Access Compliance Report

Public Rights-of-Way

(Curb Ramps)

Intersection ID: 11695	Main Street: PARKWOOD_AV	Cross Street: THE_PLAZA	Location: W
ADA ID: 870B709EEBDE	Ramp Type: Perp	Initial Pass/Fail: Fail	Overall Compliance: No
Severity Score: 25			
Codes/Mitigation Info/Possible Solution		Field Measurements/Component Compliance

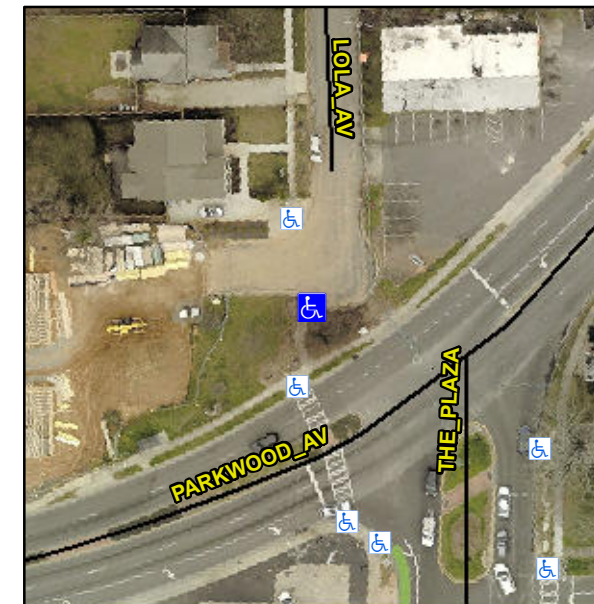
Not Found, R304.2.2

Compliance	Description	Data	Compliance	Description	Data
N/A	Ramp Length (in)	60.0	No	Ramp Slope (%)	13.4
Yes	Ramp Width (in)	66.0	Yes	Ramp XSlope (%)	0.5
N/A	Flare Type LT	N/A	N/A	Flare Type RT	N/A
N/A	Flare Slope LT (%)	N/A	N/A	Flare Slope RT (%)	N/A
N/A	Flare Traversable LT?	N/A	N/A	Flare Traversable RT?	N/A
N/A	Landing Length (in)	N/A	N/A	DWS Provided?	N/A
N/A	Landing Width (in)	N/A	N/A	DWS Contrast?	N/A
N/A	Landing Slope (%)	N/A	N/A	DWS Length (in)	N/A
N/A	Landing X Slope (%)	N/A	N/A	DWS Full Width?	N/A
N/A	Landing Curb? (Y/N)	N/A	N/A	DWS Offset (in)	N/A
N/A	Shared Landing?	N/A			
N/A	Gutter Ponding?	N/A	N/A	Gutter Slope (%)	N/A
N/A	Gutter Lip Ht (in)	N/A	N/A	Gutter X Slope (%)	N/A
N/A	Painted X Walk1?	No	N/A	Painted X Walk2?	N/A
	X Walk 1 Direction	To NW		X Walk 2 Direction	N/A
N/A	X Walk 1 Width (in)	N/A	N/A	X Walk 2 Width (in)	N/A
	X Walk 1 Slope (%)	0.8		X Walk 2 Slope (%)	N/A
	X Walk 1 X Slope (%)	0.7		X Walk 2 X Slope (%)	N/A

Remove & Replace Entire Ramp.
